# WOLF CREEK

WM 92-0035

Subject: Docket No. 50-482: Inservice Inspection Program  
Relief Requests

ISI RELIEF REQUEST IIR-23

FIGURE 1

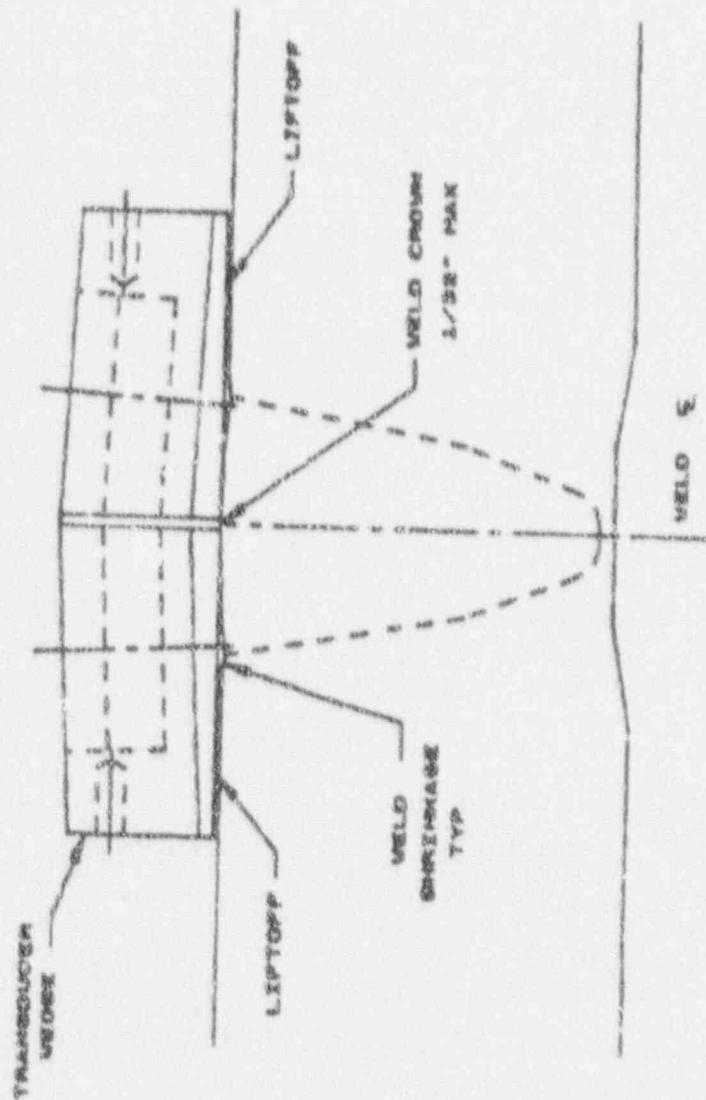
Basis for Relief: The transducers used to examine Cast Stainless Steel (CSS) were too large to maintain sufficient contact in the circumferential scanning mode (reference Figure 1). They did, however, maintain adequate contact when scanning perpendicular to the weld axis.

With welds F207, F307, F407, F305, F405 and F306, the weld crown and weld shrinkage causes transducer lift off. With welds F203 and F303, the weld taper causes transducer lift off.

Basis for Relief: The transducers used to examine Cast Stainless Steel (CSS) material were too large to maintain sufficient contact when running along the weld crown (circumferential examination). Thus, resulting with 0% inspection using the circumferential scan (reference Figure 1).

Alternate Examination: The code required volumetric examination will be completed perpendicular to the weld axis from two (2) directions.

Alternate Examination: The code required volumetric examination will be completed perpendicular to the weld axis from two (2) directions.

Figure 1

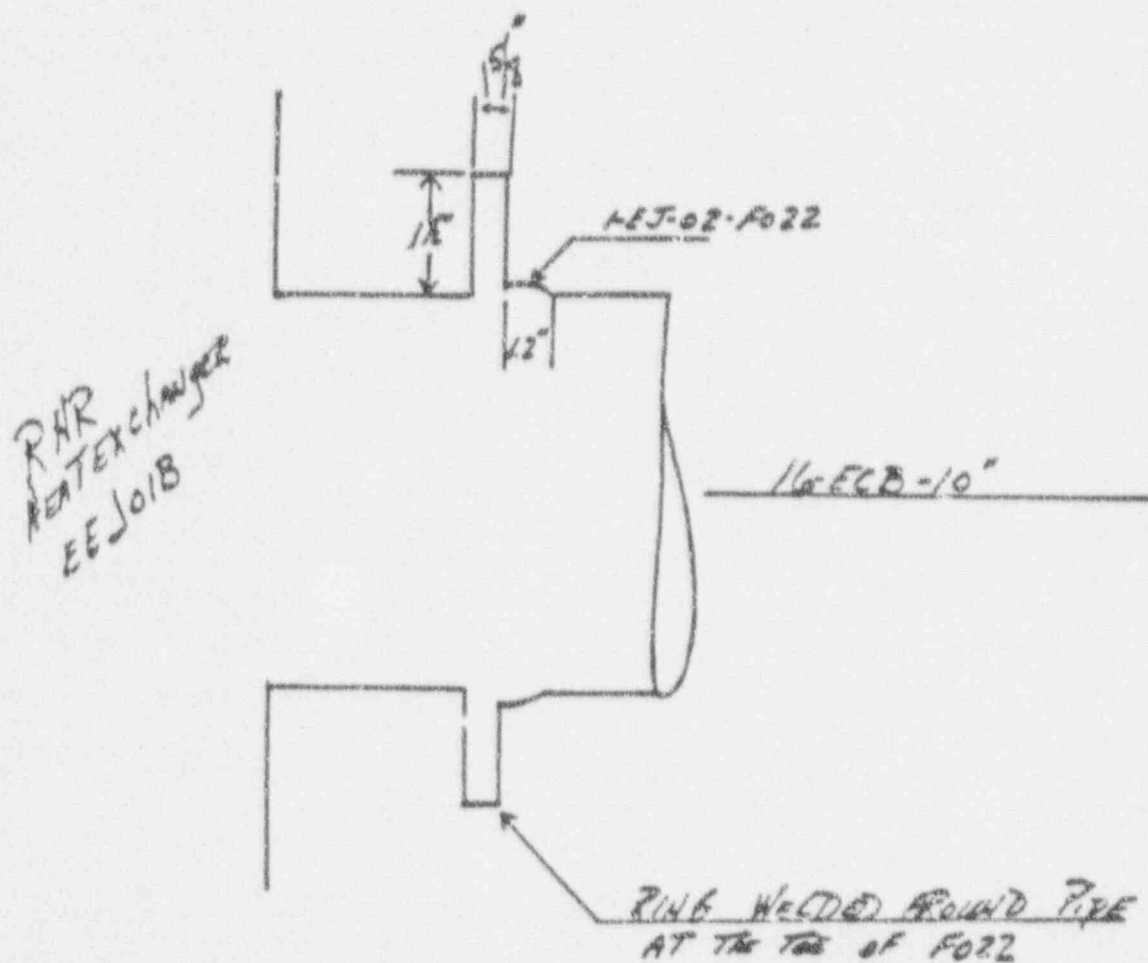
Basis for Relief: The surface examination of the subject weld is 39% obstructed by a 1 1/2" by 1 5/8" ring. The ring is welded over the downstream toe of the weld; therefore, making it impossible to get the required 1/2" coverage beyond the toe of the weld. To examine the obstructed area would require physically removing the welded ring (reference Figure 1).

Alternate Examination: None; the Code required surface examination will be completed to the maximum extent practical.

Figure 2

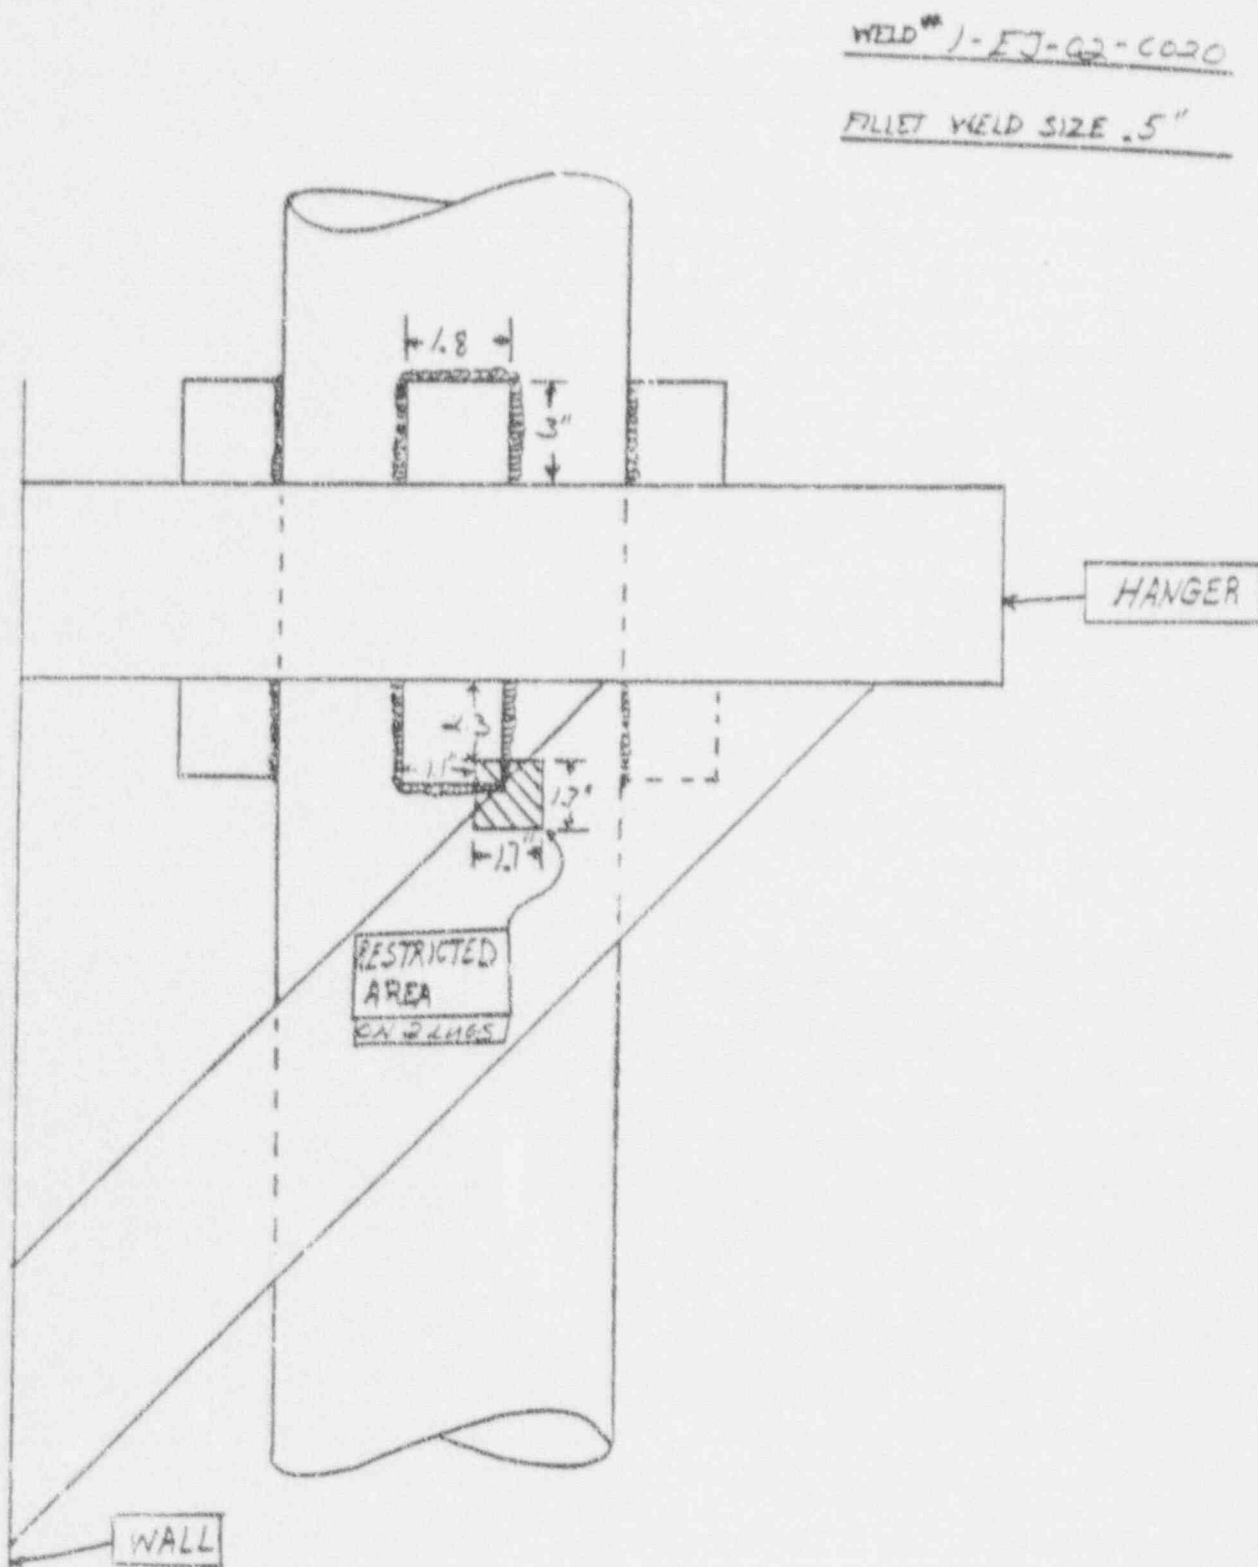
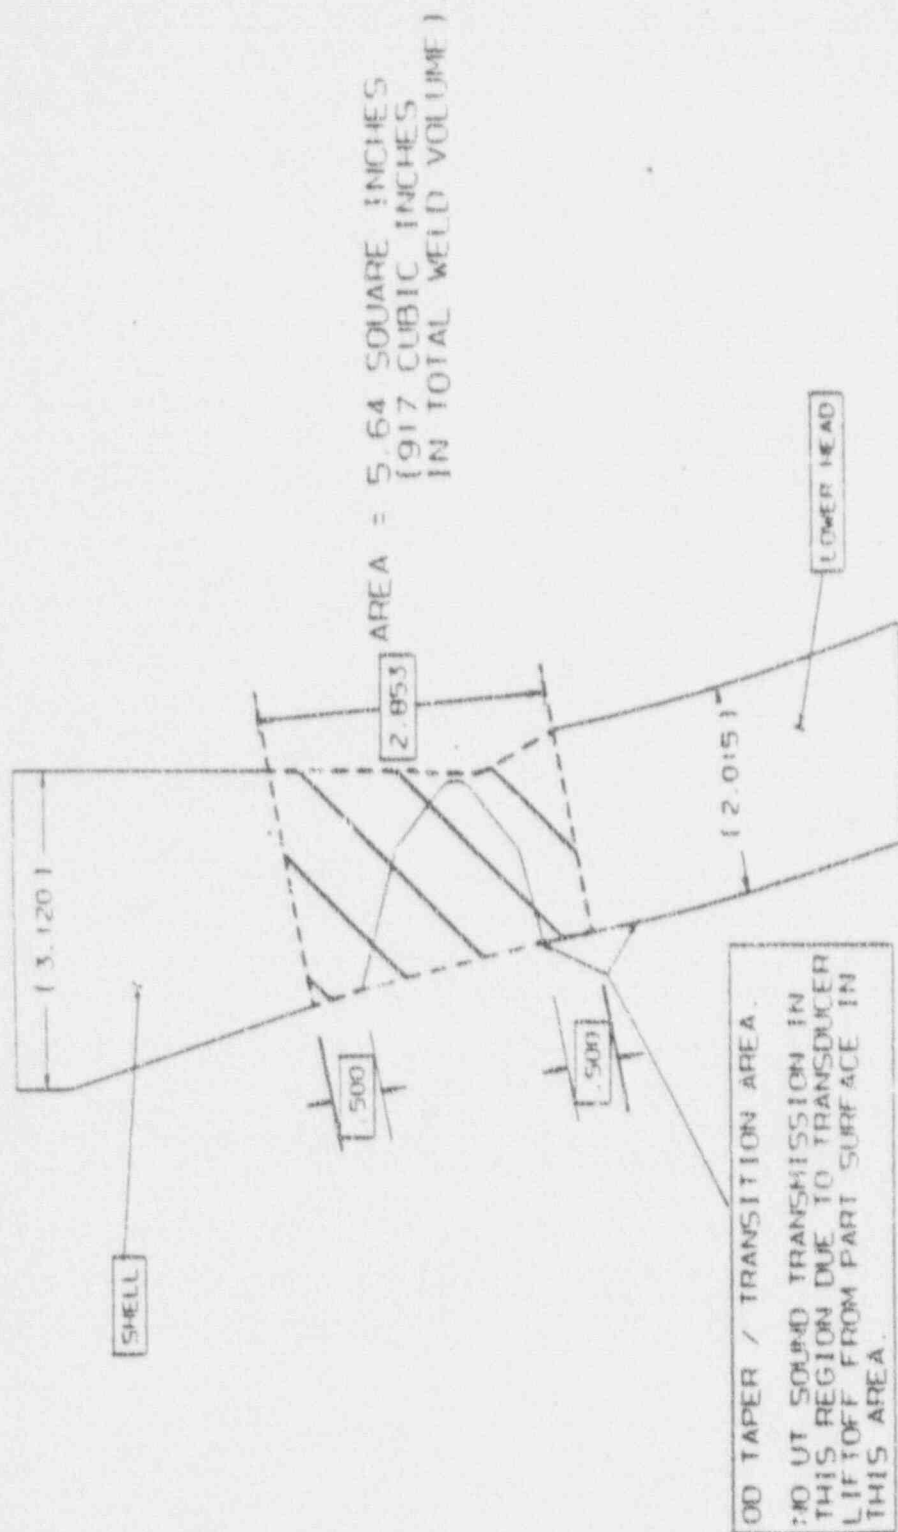
Basis for Relief: The surface examination of the subject integrally welded attachments (lugs) are 24% obstructed on two (2) of the lugs. The obstruction is a result of a permanent hanger that is used to support the Residual Heat Removal (RHR) piping. The diagonal supports of this hanger cross over the required inspection area on two of the lugs (reference Figure 2).

Alternate Examination: None; the Code required surface examination will be completed to the maximum extent practical.

Figure 3A

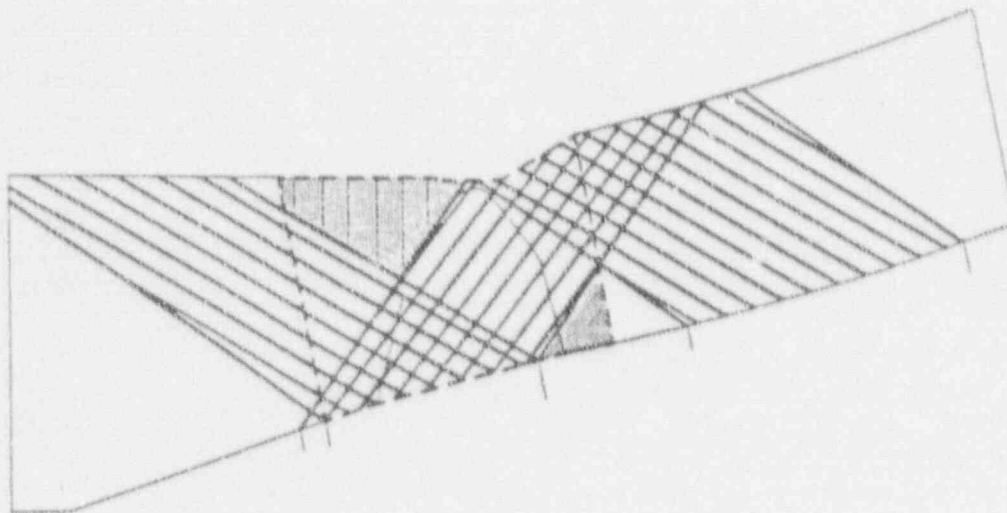
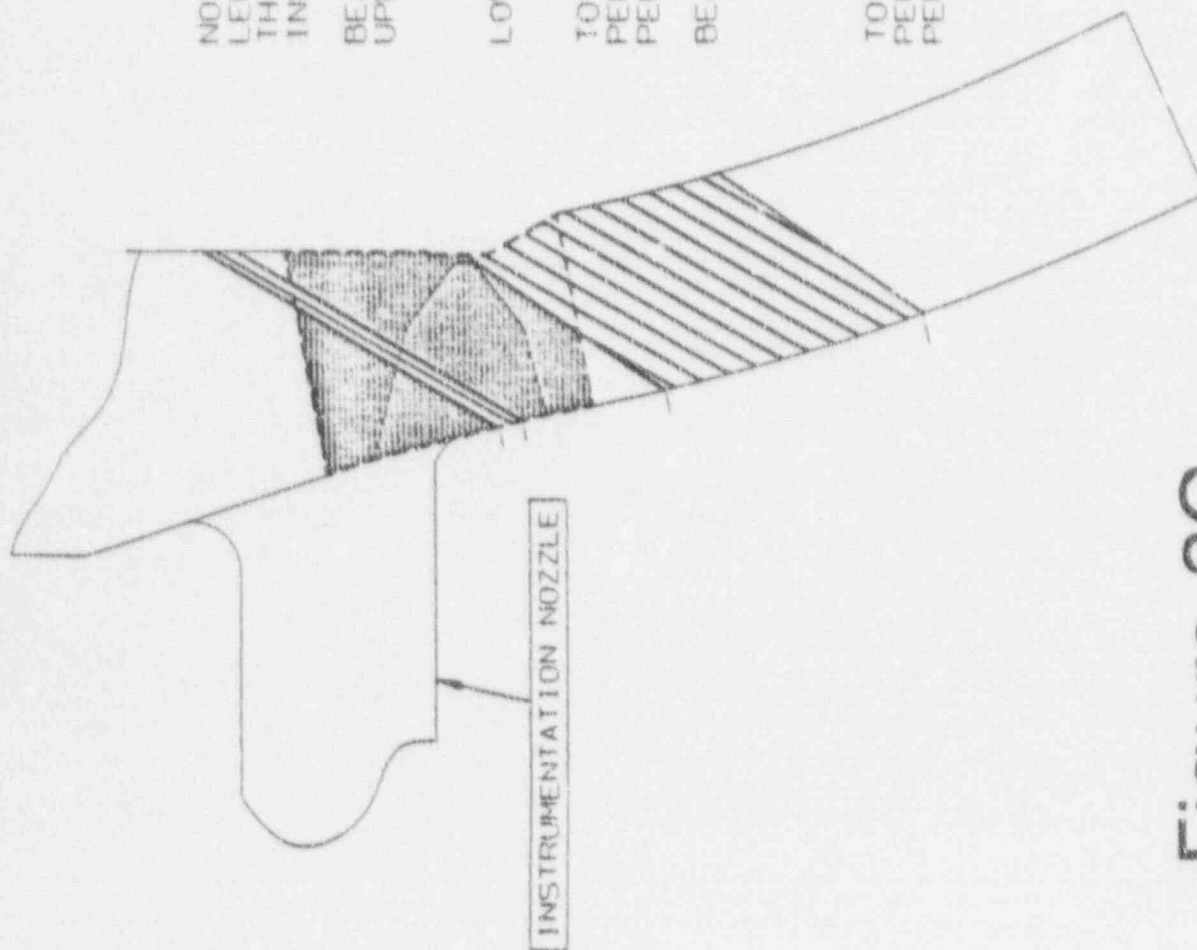
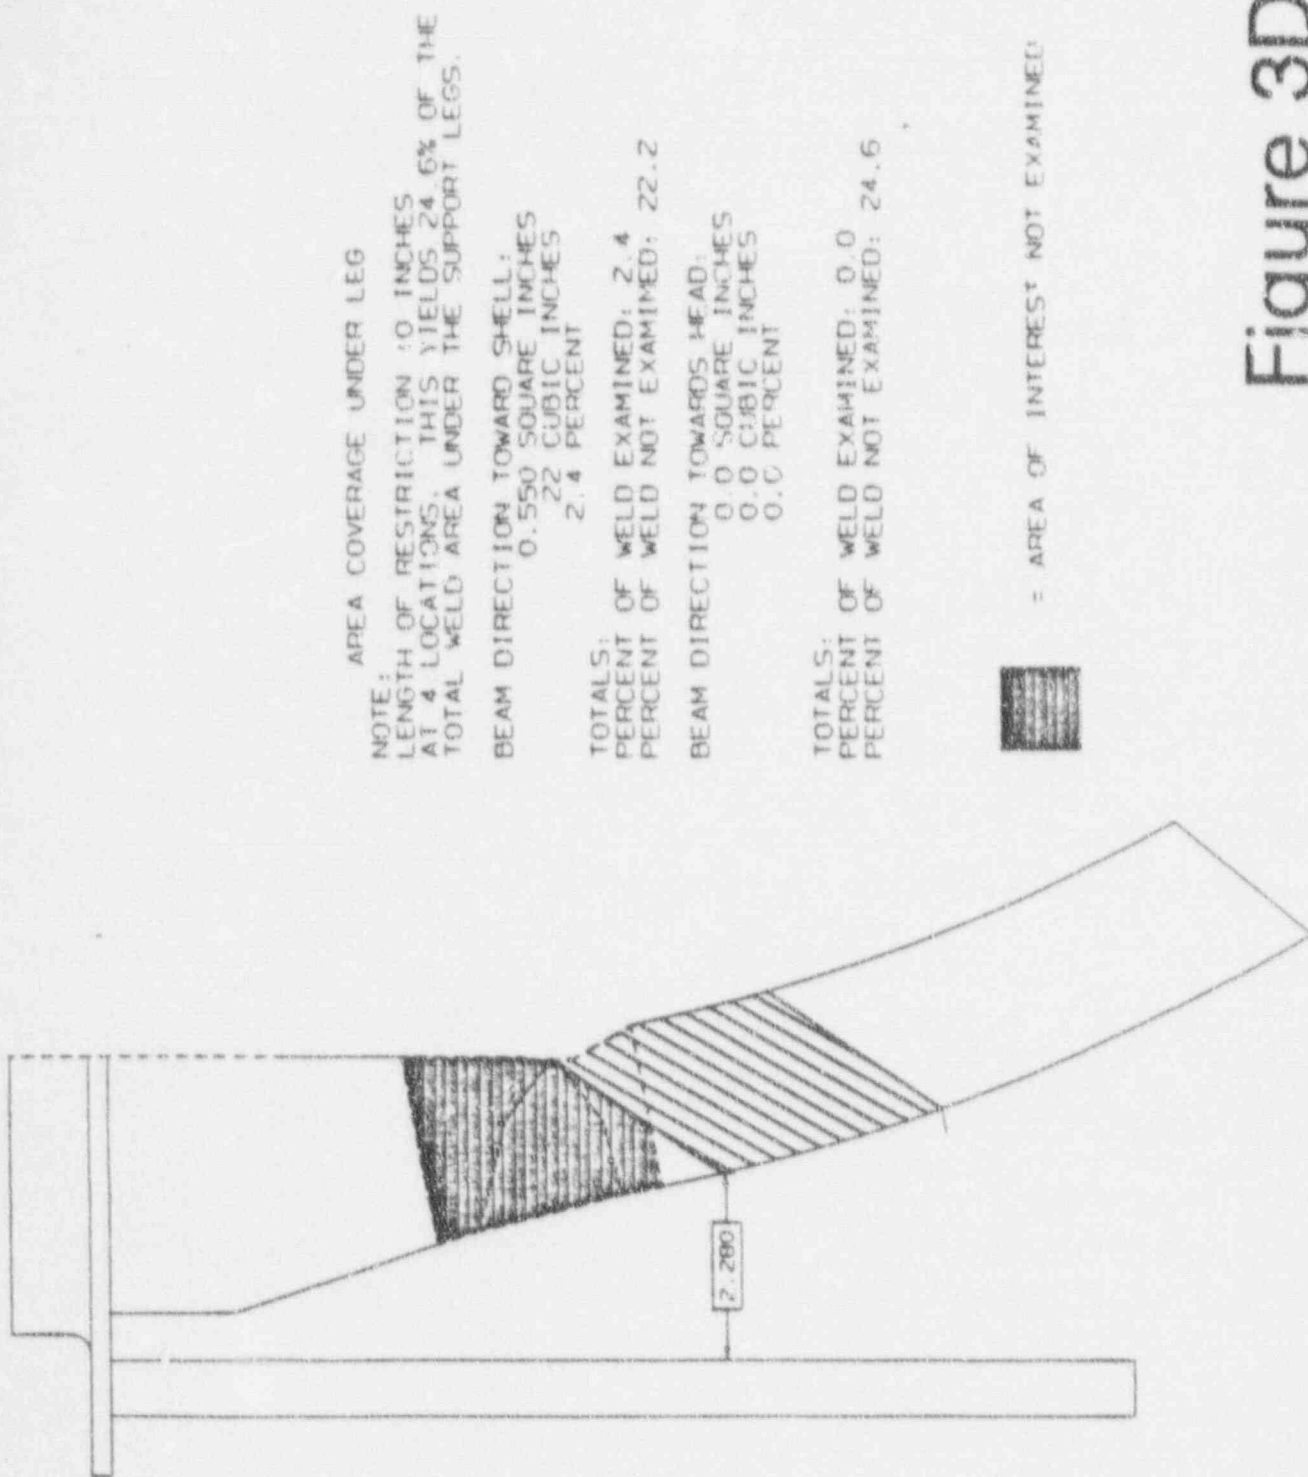
Basis for Relief: The volumetric examination of the subject weld is limited in the following way:

<u>LIMITATIONS</u>	<u>BEAM TOWARD</u>	<u>BEAM TOWARD</u>
	<u>SHELL</u>	<u>HEAD</u>
Weld Configuration	-57%	-33%
Leg Supports	-22%	-25%
Instrumentation Nozzle	- 4%	- 5%
Total Weld Coverage	17%	37%

The circumferential examination was 100% limited due to the weld configuration (reference Figures 3A through 3D for the percentage breakdown).

Alternate Examination: None; the Code required volumetric examination will be completed to the maximum extent possible.

Figure 4

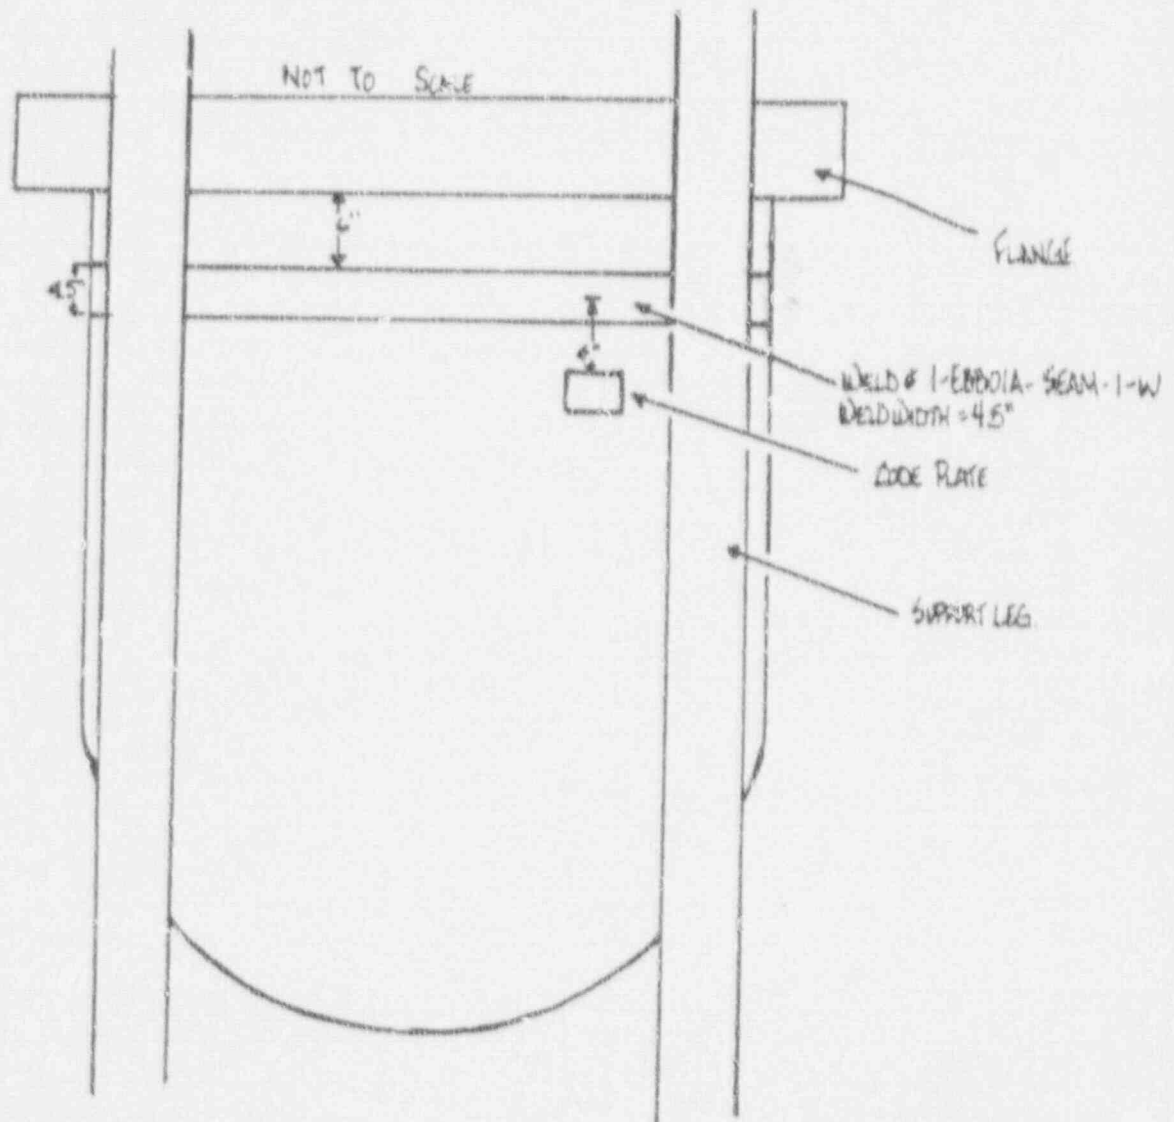
Basis for Relief: The volumetric examination of the subject weld is 22.4% obstructed by four (4) supports. The 60° axial scan on the tubesheet side is 20% obstructed by the support flange. The obstruction results from insufficient base metal between the weld and flange to complete this angle beam examination. There is approximately 1% obstruction due to weld taper and the code data plate. Reference Figure 4 for weld layout.

Alternate Examination: None; the Code required volumetric examination will be completed to the maximum extent practical.
